# ABINGTON TOWNSHIP

**JANUARY 11, 2024**

## **BOARD OF COMMISSIONERS WORKING SESSION**

**RE: Executive Summary for LD-23-04-640 Cedar Road (Hopewell Vet)  
PARID: 30-00-06992-00-7/ TMID: 30049 004  
Preliminary/Final Major Land Development Plans Review (1<sup>st</sup> Submission)**

CONSTRUCTION DETAILS & STORM PROFILES  
OF  
**640 CEDAR ROAD**  
ABINGTON TOWNSHIP, MONTGOMERY COUNTY, PA  
PREPARED FOR  
HOPEWELL VETERINARY HOSPITAL

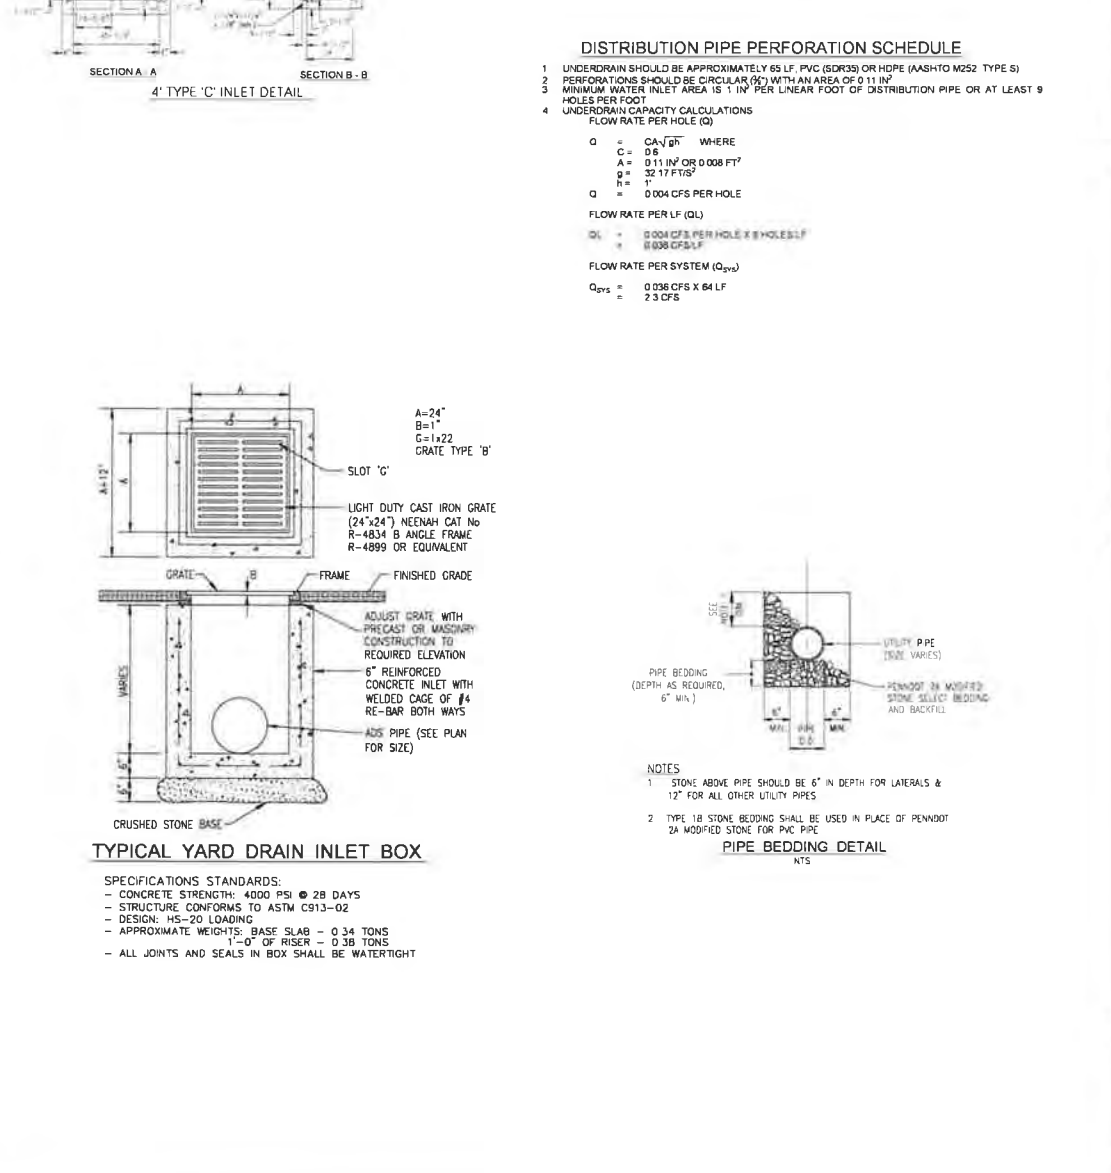
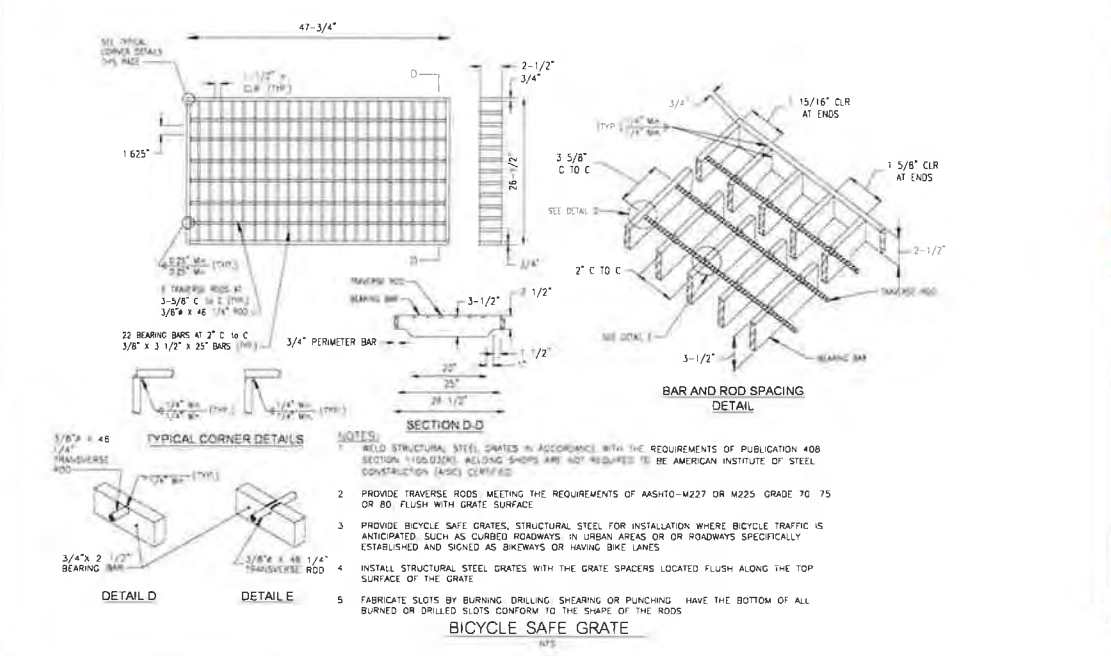
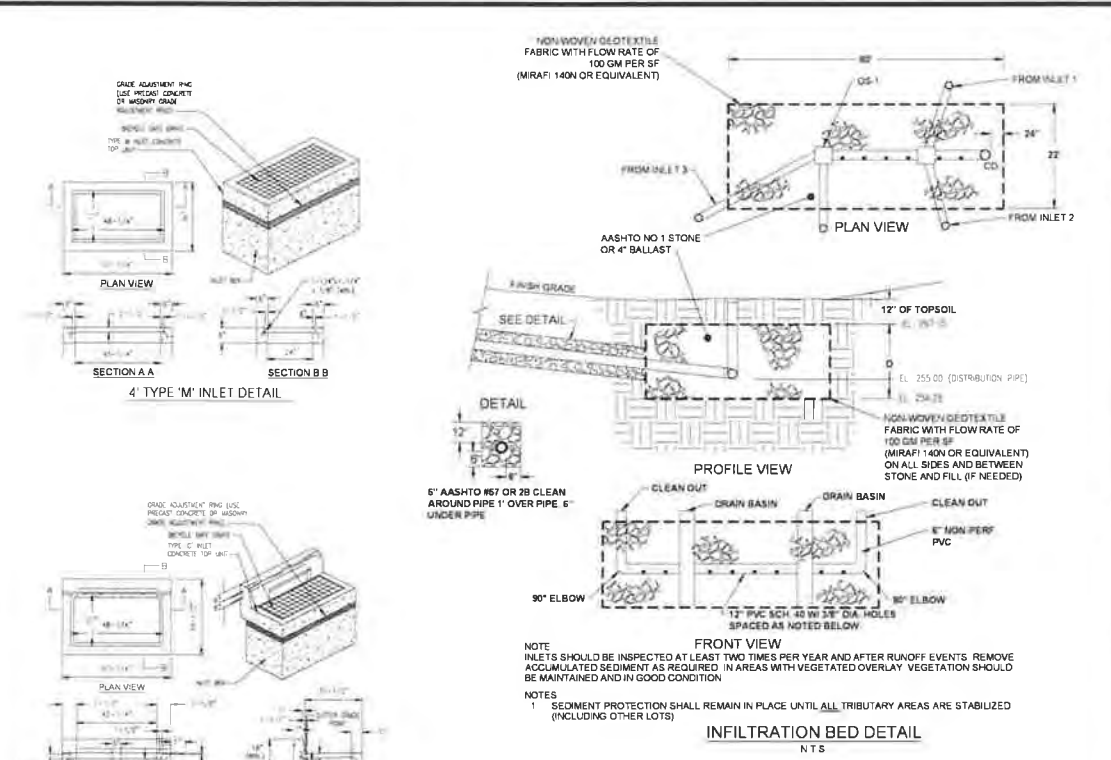
39. There are two discrepancies between the elevations provided on the Grading & Utility Plan (Sheet 5), the elevations provided on the storm profiles (Sheet 8), and the elevations provided in the PCSM Report (Pages 21-23). The discrepancies are as follows:

Landscape Details

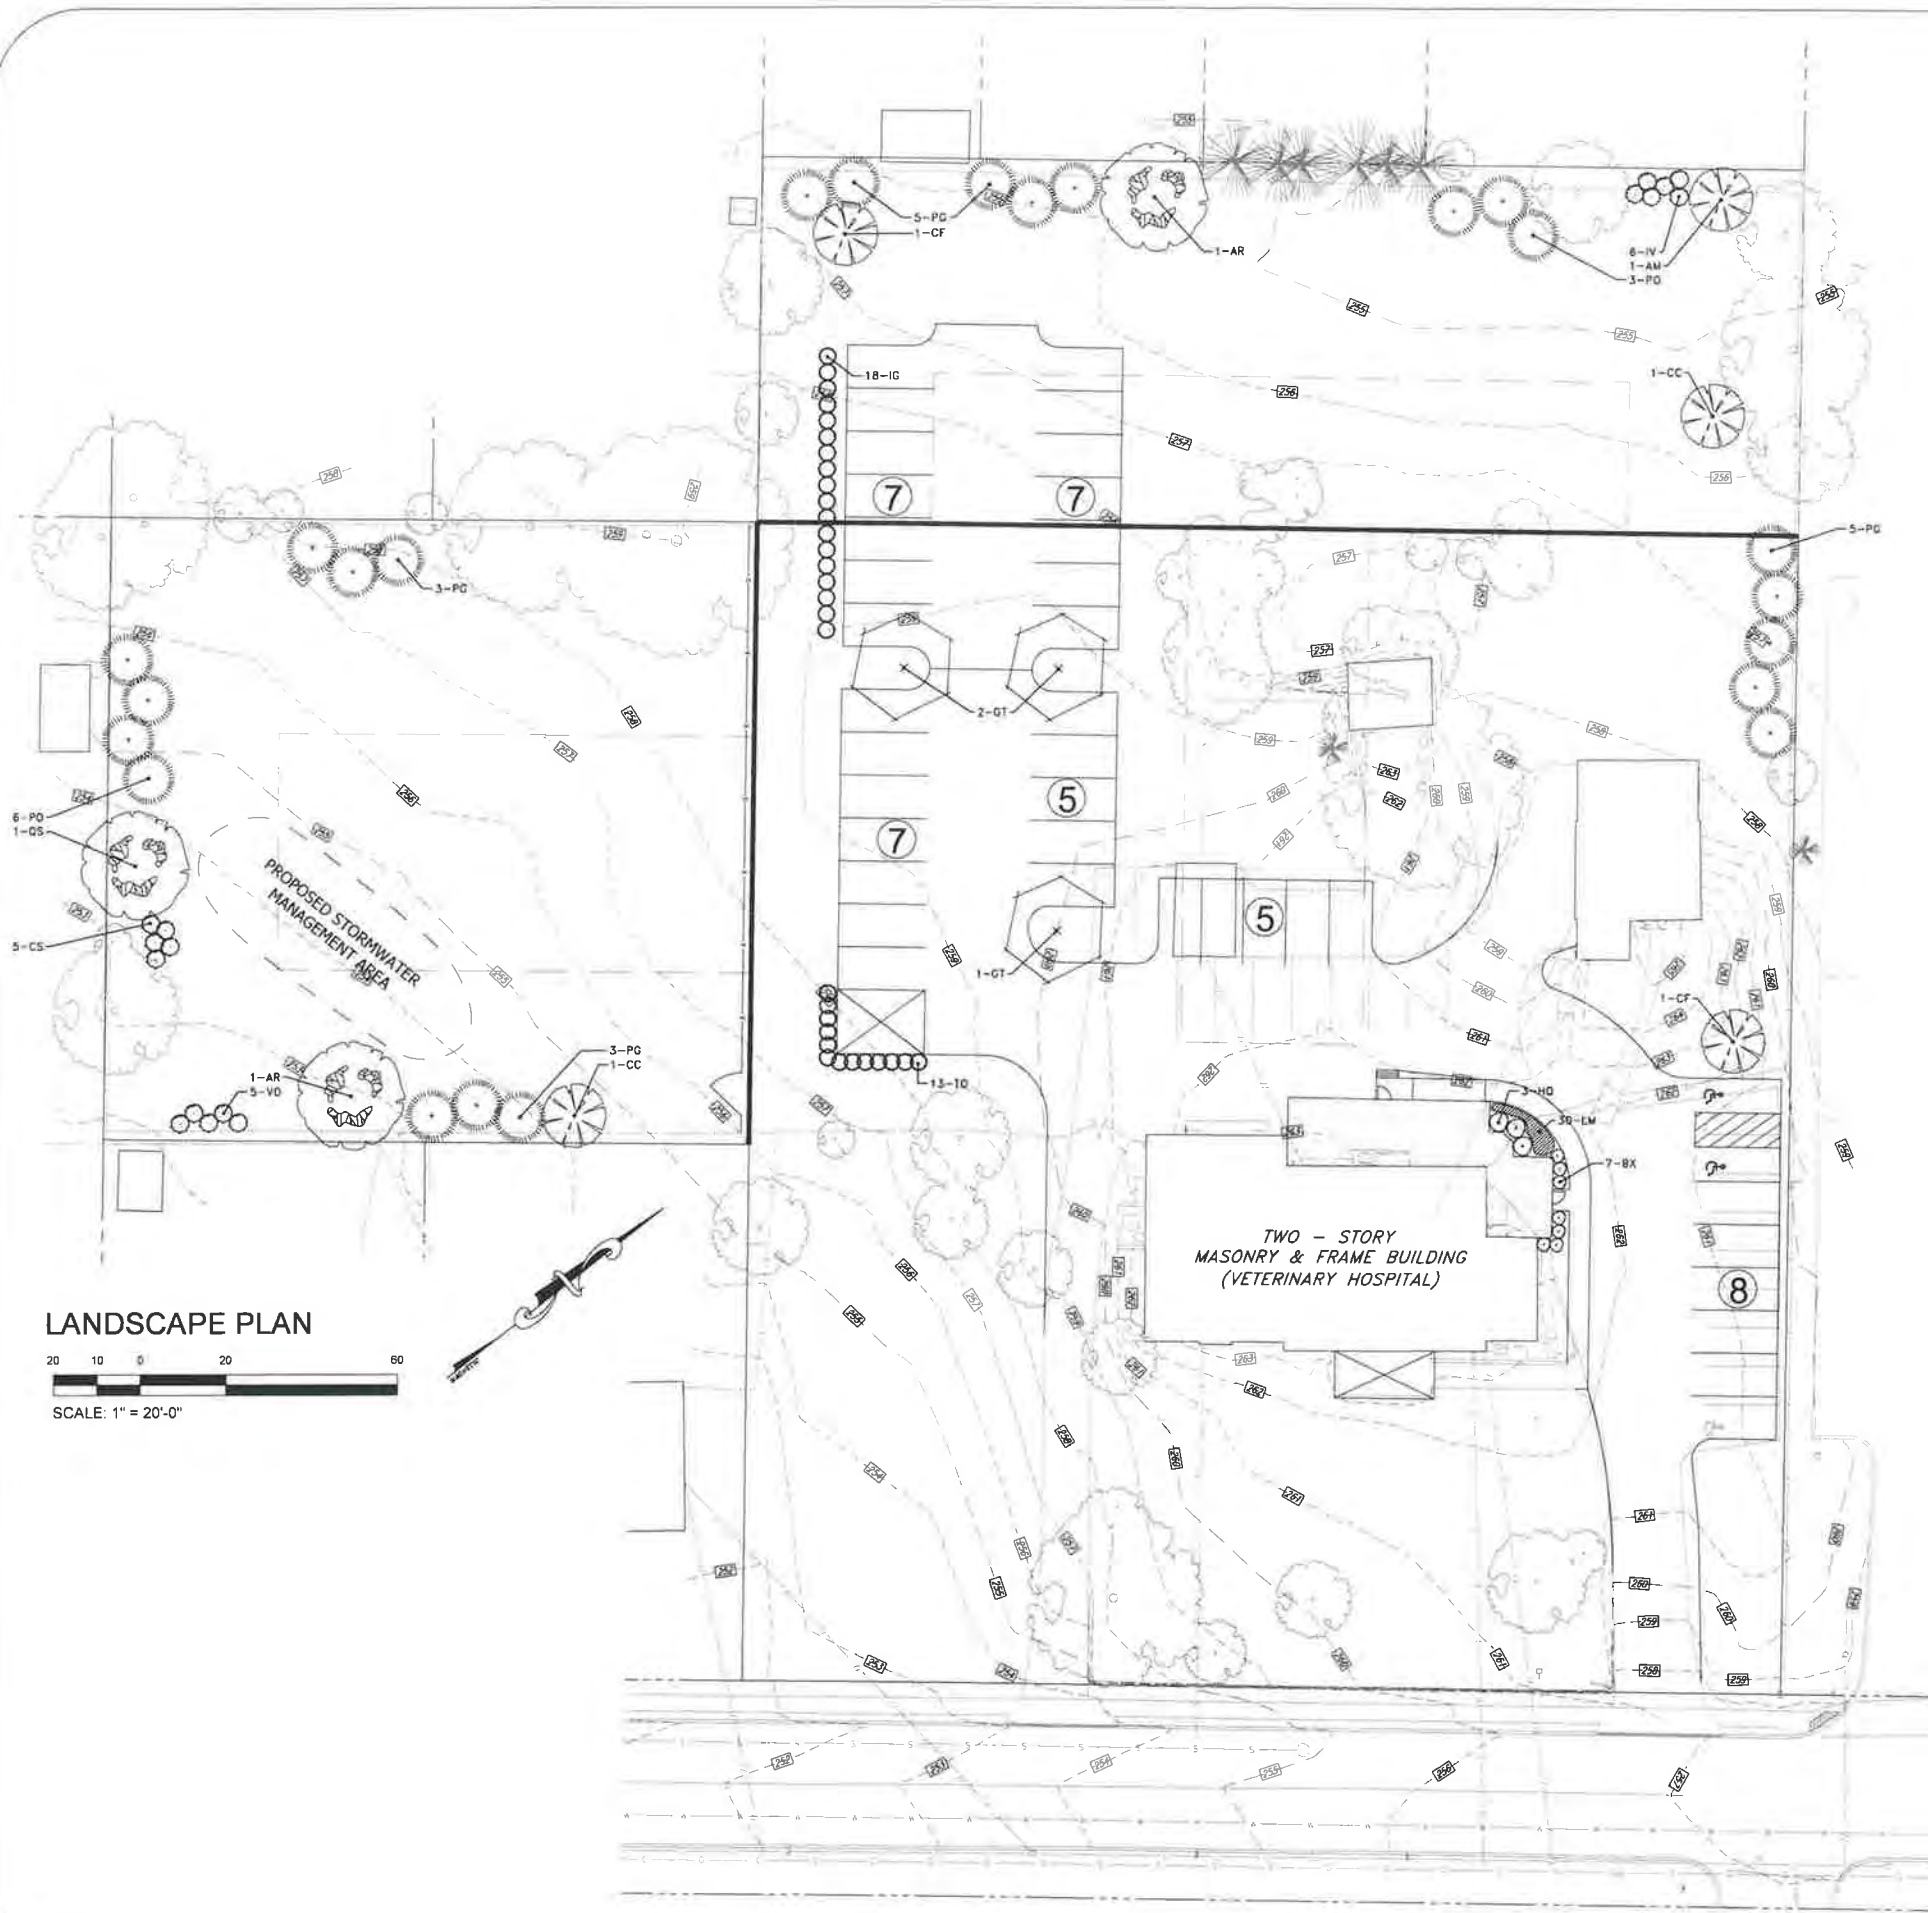
**On the Landscaping Details (Sheet LP-2), the planting schedule indicated the minimum caliper size of 2.5 inches for the Acer Rubrum shade trees. Per the above Code Section, the shade trees shall be a minimum caliper of 3 inches, branching at 6 feet to 8 feet in height. The planting schedule shall be revised accordingly to reflect the minimum caliper size of 3 inches.**
